# CELEBES SEA, EASTERN PORTION—TALAUTSE ISLES.

No. 312 (first publication).—The following particulars, etc., relative to the above, issued by the British Admiralty (No. 1158 of 1921), are republished:—

Reproduction of Portion of Chart No. 942b

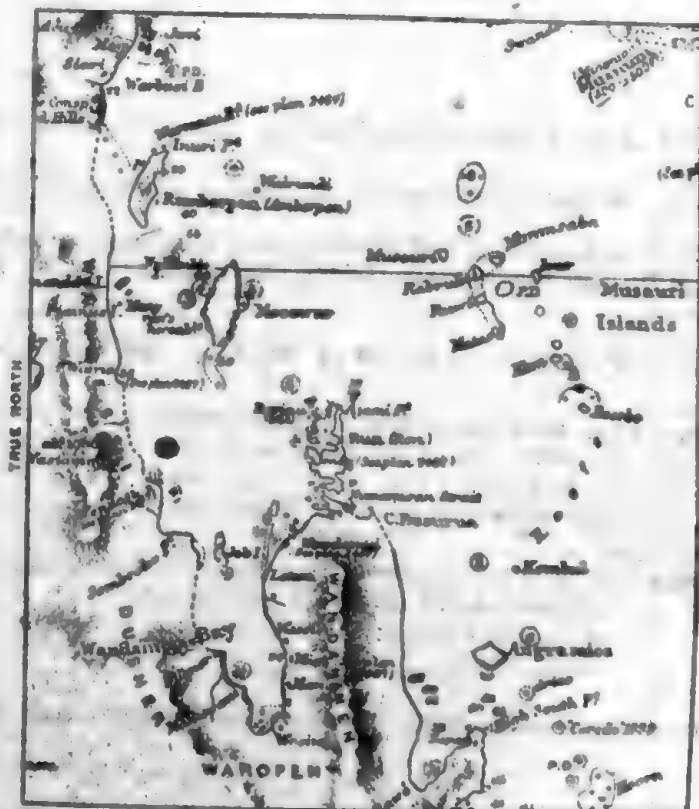
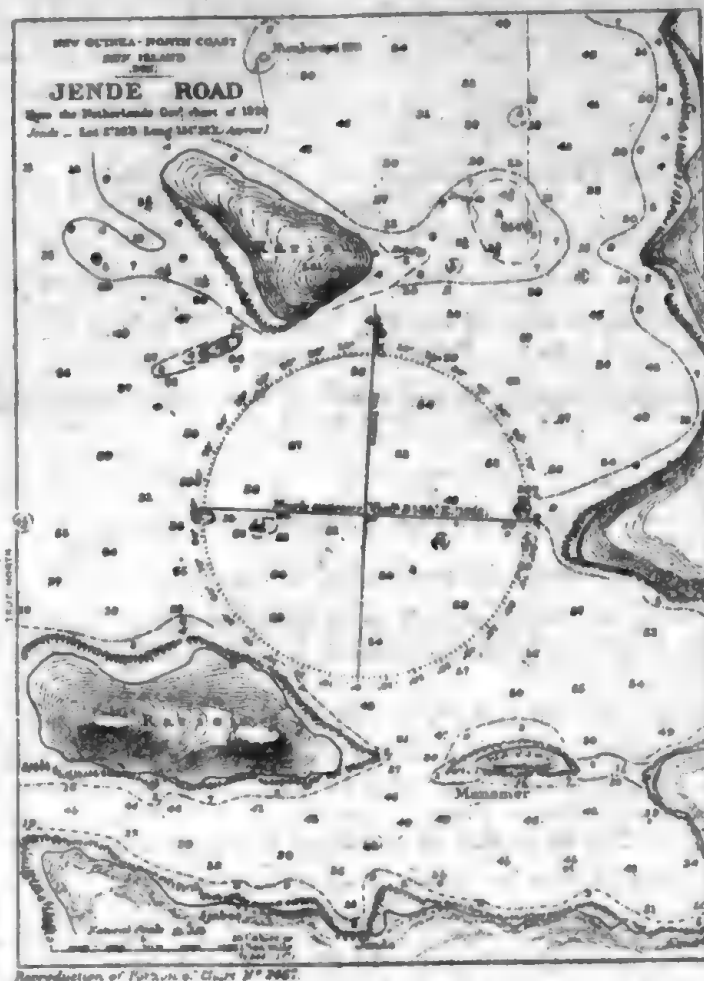
**Details.**—Amendments to charts with regard to coastline, depths and shoals in the vicinity of Run island are shown on the accompanying reproductions of a portion of chart No. 942b and of the plan of Jende road on chart No. 2467.

*Charts affected.*—No. 942a, Eastern archipelago—sheet 3.

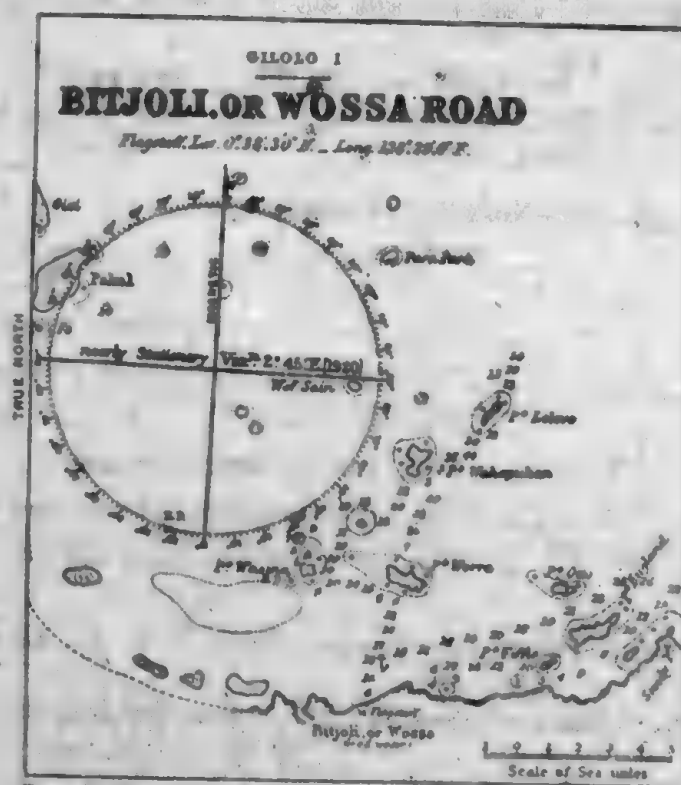
*Details.*—The accompanying reproduction of a portion of chart No. 942a and of the plan of Bitjoli or Wossa road on chart No. 930 shows the necessary corrections to those charts with regard to reefs in Wossa bay.

Reproduction of Portions of Chart No. 653

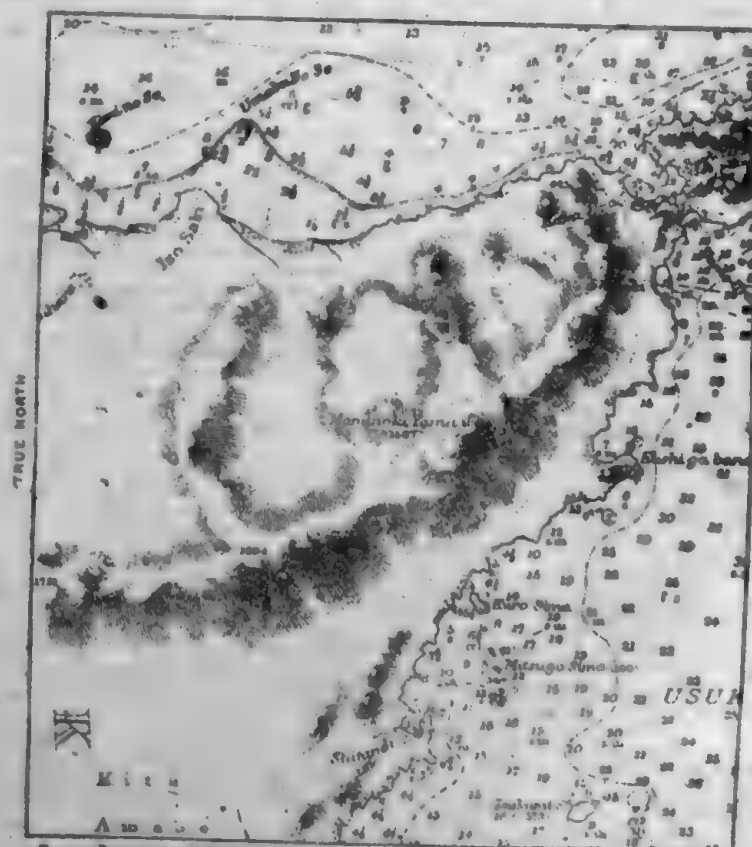
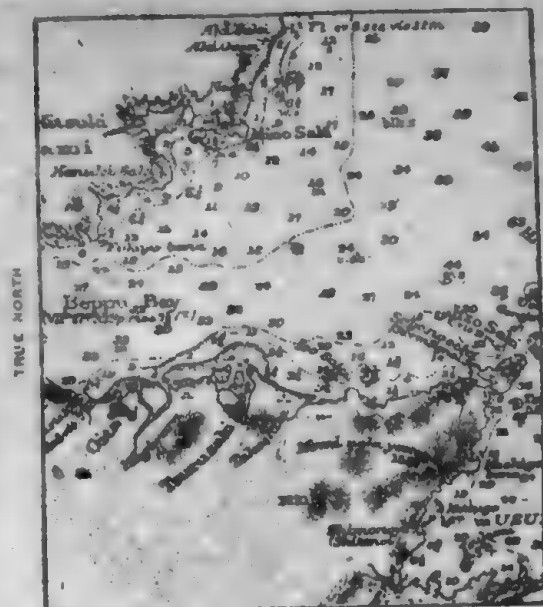
*Details.*—Amendments with regard to shoals in Beppu and Usuki bays are shown on the accompanying reproductions of portions of charts Nos. 651, 2875 and 1648.

*Reproduction of Portion of Chart N° 1578.*

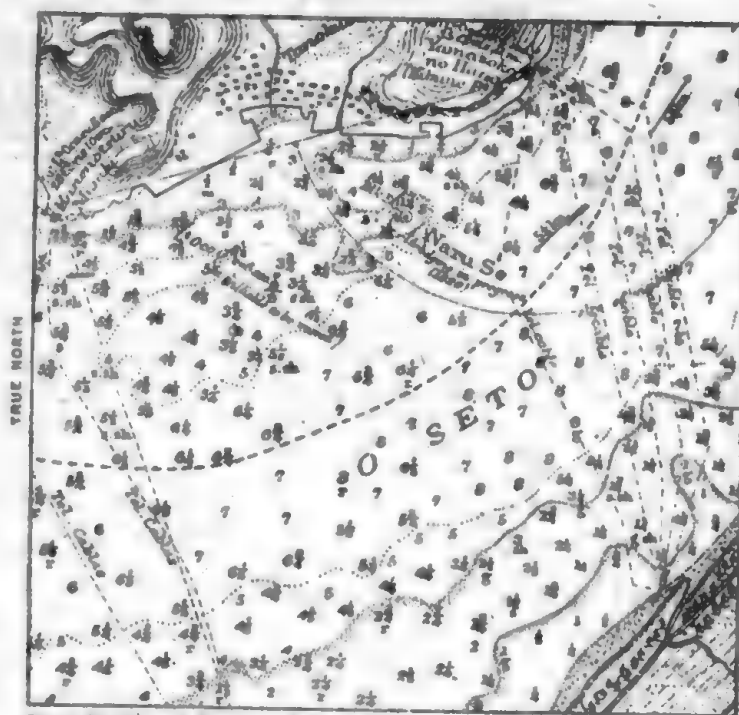
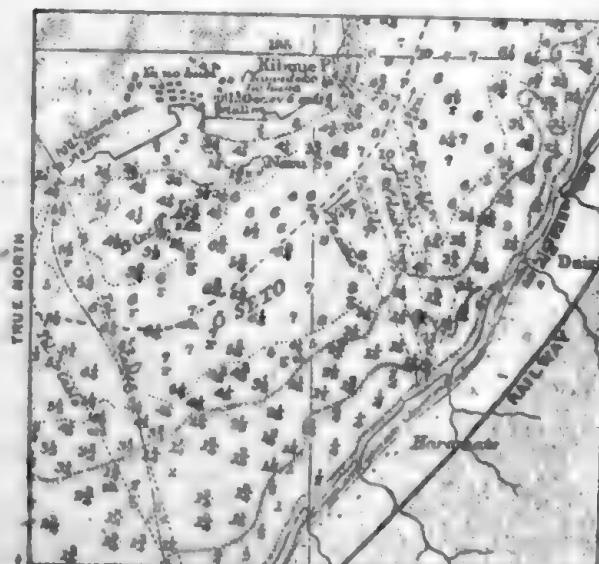
*Details.*—The accompanying reproduction of portions of charts No. 1578 and 532 shows the necessary corrections to those charts with regard to new positions of telegraph cables across O seto.

*Charts affected.*—No. 2467, Plan of Jende road.

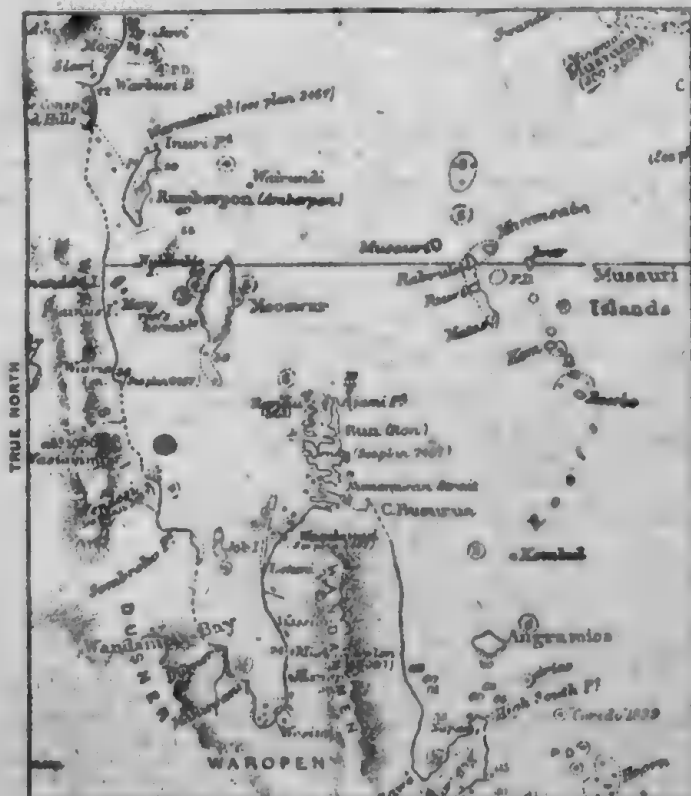
*Details.*—Amendments to charts with regard to coastline, depths and shoals in the vicinity of Run island are shown on the accompanying reproductions of a portion of chart No. 9426 and of the plan of Jende road on chart No. 2467.

*Charts affected.*—No. 942a, Eastern archipelago—sheet 3.

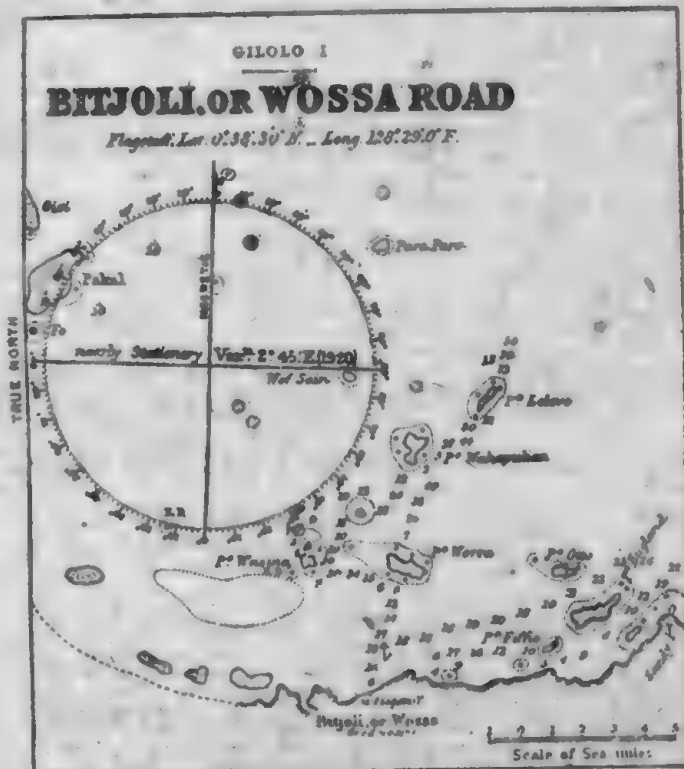
*Details.*—The accompanying reproduction of a portion of chart No. 942a and of the plan of Bitjoli or Wossa road on chart No. 930 shows the necessary corrections to those charts with regard to reefs in Wossa bay.

Reproduction of Portions of Chart No 651

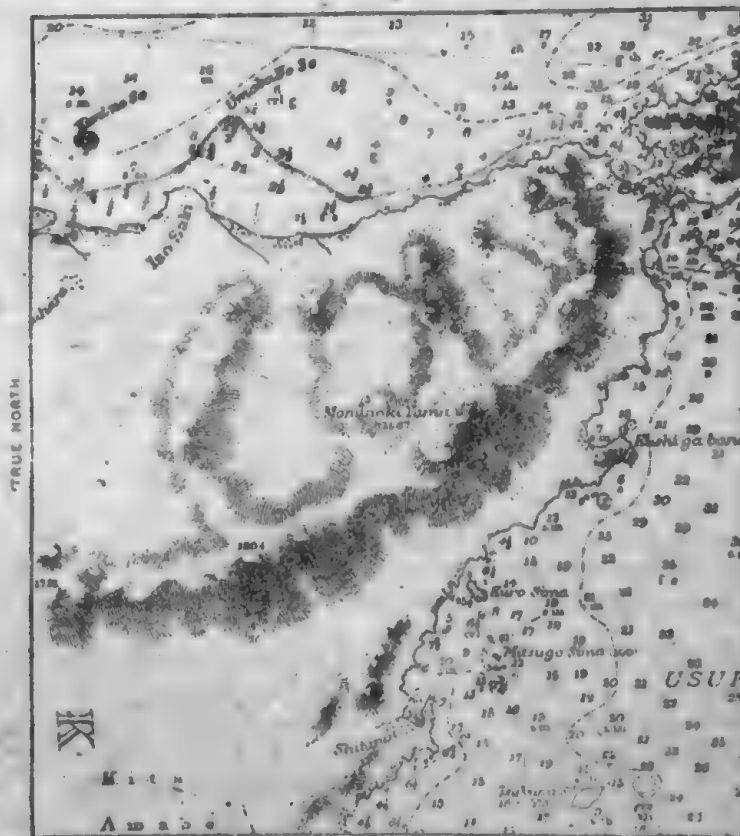
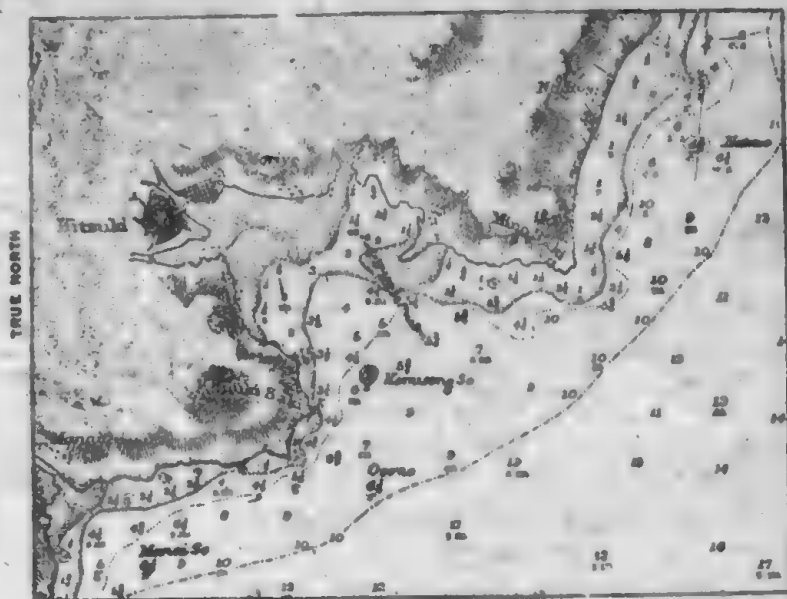
*Details.*—Amendments with regard to shoals in Beppu and Usuki bays are shown on the accompanying reproductions of portions of charts Nos. 651, 2875 and 1648.

Reproduction of Portion of Chart N° 1578.

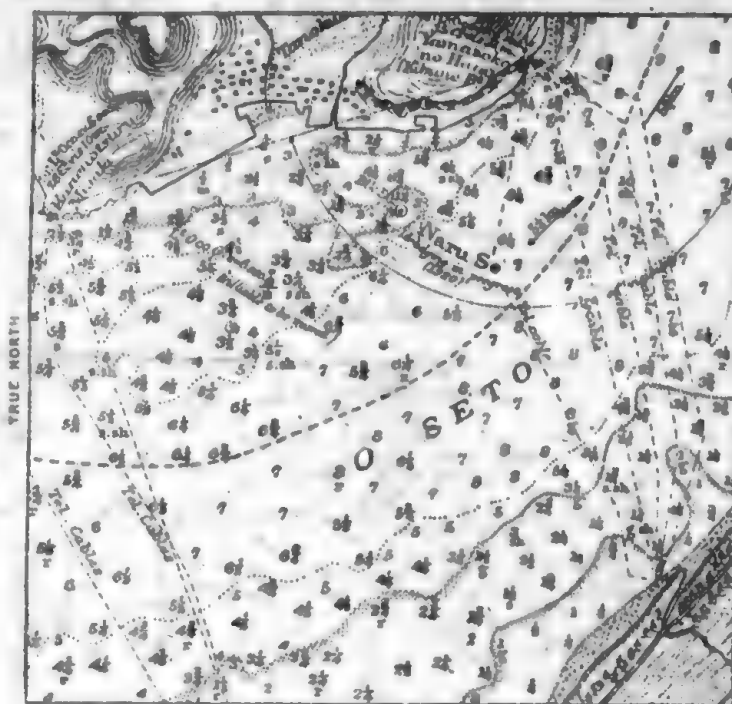
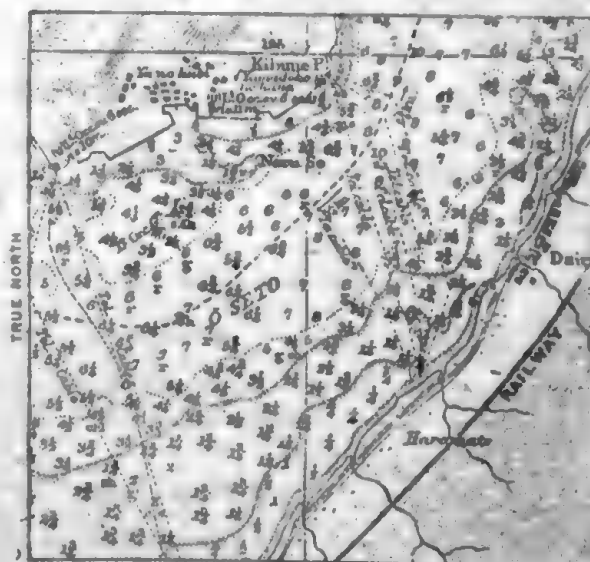
*Details.*—The accompanying reproduction of portions of charts No. 1578 and 532 shows the necessary corrections to those charts with regard to new positions of telegraph cables across O seto.

Reproduction of Portion of Chart No. 9426

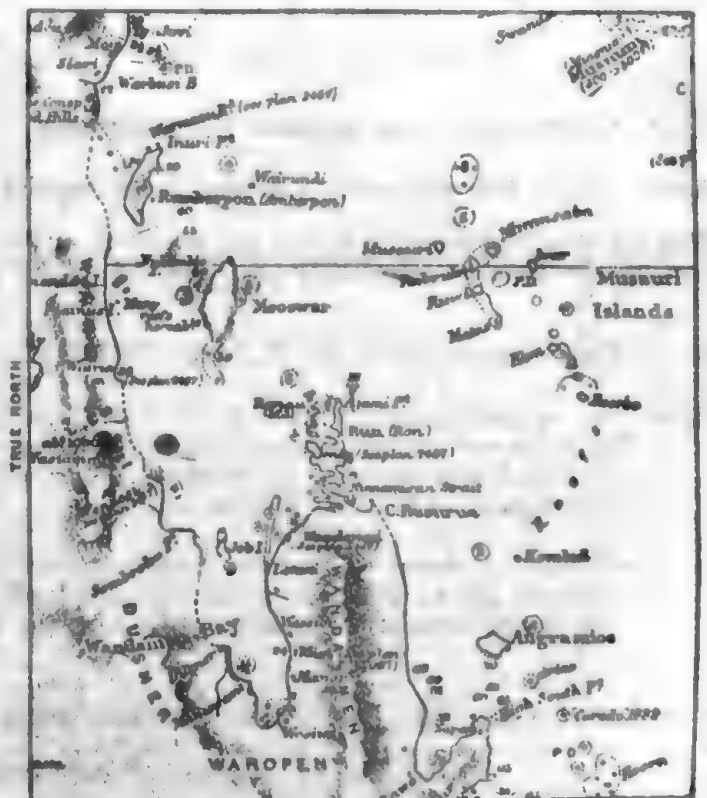
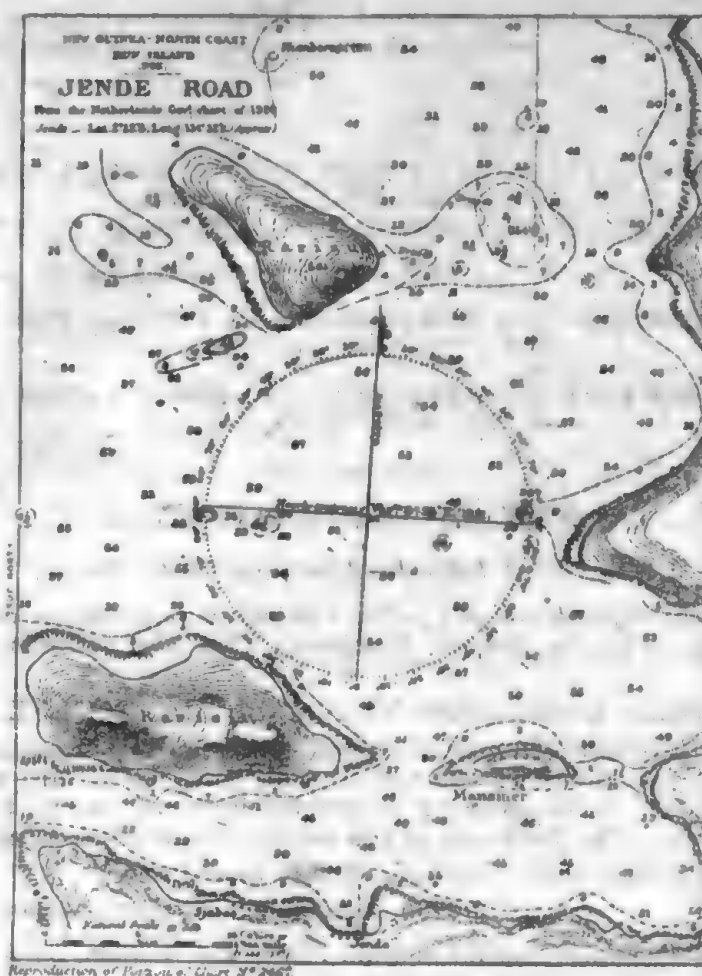
*Details.*—Amendments to charts with regard to coastline, depths and shoals in the vicinity of Run island are shown on the accompanying reproductions of a portion of chart No. 9426 and of the plan of Jende road on chart No. 2467.
